**THE ENSTROM HELICOPTER CORPORATION**

# **SERVICE INFORMATION LETTER**

SERVICE INFORMATION LETTER NO. 0167

1. SUBJECT: Sliding Window Installation
2. MODEL: F-28A, 280, F-28C, 280C, F-28F, 280F, and 280FX
3. EFFECTIVITY: All
4. BACKGROUND:

**Figure 1**

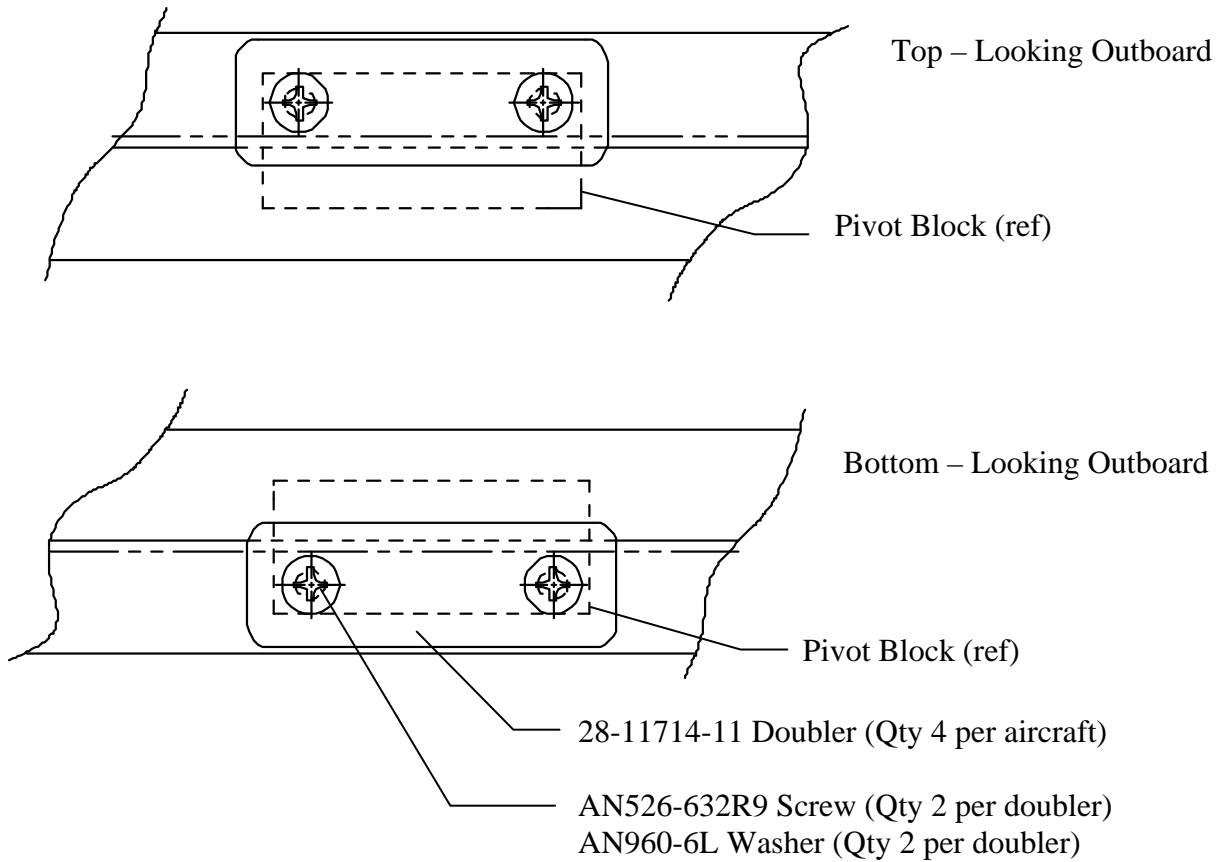
Enstrom has received reports regarding cracks generated about the sliding window frame at the location of either the upper or lower vent window pivot blocks. The cause for cracks has not been identified but may be attributed to the quality of the workmanship during production assembly, such as overtightening hardware and/or improper deburring of the attachment holes in the acrylic window structure. For an improvement, Enstrom has designed a doubler installation to reinforce the door window in the area of the pivot blocks.

- A. Slide the window aft to avoid damaging the window during the doubler installation.
- B. Remove the two screws that are installed from the inside of the window that screw into the wing window hinge blocks.
- C. Inspect the screw holes for cracks. If cracks are detected, contact Customer Service.
- D. Position the doubler by aligning the two attachment holes of the doubler with the two holes used to attach the pivot block. See Figure 1.
- E. Install the attachment hardware listed in paragraph 5.2 (8 in-lb max. torque).

**CAUTION****Do not overtorque hardware.**

Description	Part Number	Quantity
Doubler	28-11714-11	4
Screw	AN526-632R9	8
Washer	AN960-6L	8
